UNITED STATES PATENT AND TRADEMARK OFFICE

Office Action Summary	Application No. 10/553,973	Applicant(s) GAZZA, GIANLUCA	
	Examiner DIANNE DORNBUSCH	Art Unit 3773

DETAILED ACTION

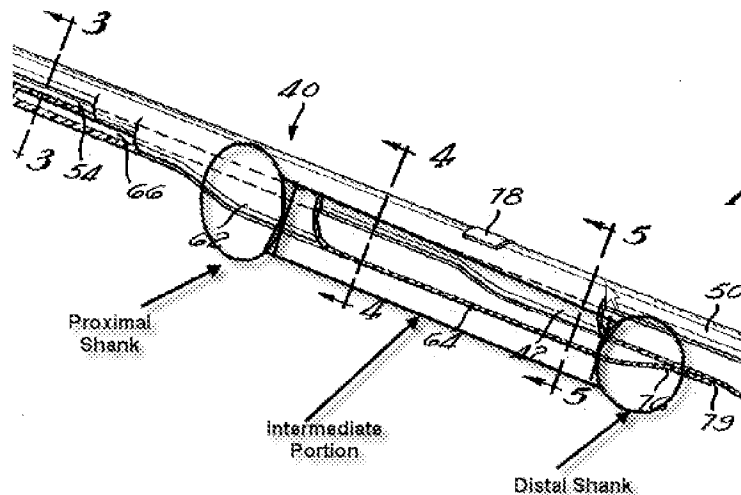
Claims 72, 101, and 105: An inflatable balloon structure (62) for catheters comprising a proximal shank (see figure below), a distal shank (see figure below), and an intermediate portion (where the cross sections 4 and 5 are taken in Fig. 2, see figure

below) between the proximal and distal shanks (see figure below); said balloon structure when the inflation chamber is expanded, has an outer surface of a circular cross-section transverse to the longitudinal extent of the balloon structure (Fig. 4-5 where it can be seen that the balloon has a circular cross-section); the balloon structure comprising a wall (64, 70, 72) which has, transverse the longitudinal extent, at any point (Fig. 1-5), an annular cross-section (Fig. 4-5), said annular cross-section being delimited externally by an outer surface (outer surface of wall 64) (Fig. 4-5) which, at least in the intermediate portion (where the cross sections 4 and 5 are taken in Fig. 2) thereof, is suitable for coming into contact with the object to be dilated (when inflated the outer surface will dilate the vessel wall), and said annular cross-section being delimited internally by an inner surface (52, 56) which delimits an inflation chamber (66), in which: at least one wall cavity (54) is provided in the wall and is formed within an annular cross-section (Fig. 4) which delimits the inflation chamber so as to be disposed between the outer surface and the inner surface the wall cavity extending, without interruptions and/or openings, longitudinally relative to the balloon structure between the proximal end and the distal end so that (fig. 3-5 and Col. 11 Lines 63-64), when the balloon structure is inflated or expanded, the outer surface of the intermediate portion has, in cross-section transverse the longitudinal extent of the balloon structure, uniform curvature around the entire annular extent of the cross-section (Fig. 4-5); the wall cavity following the balloon structure outline at least following the proximal shank and the distal shank (Fig. 1 where it can be seen that the wall cavity has the same outline as the balloon structure however they are not in face with each other).

Note that applicant does not state that the outline has to be in face with each other therefore Jang does show the outline as claimed.
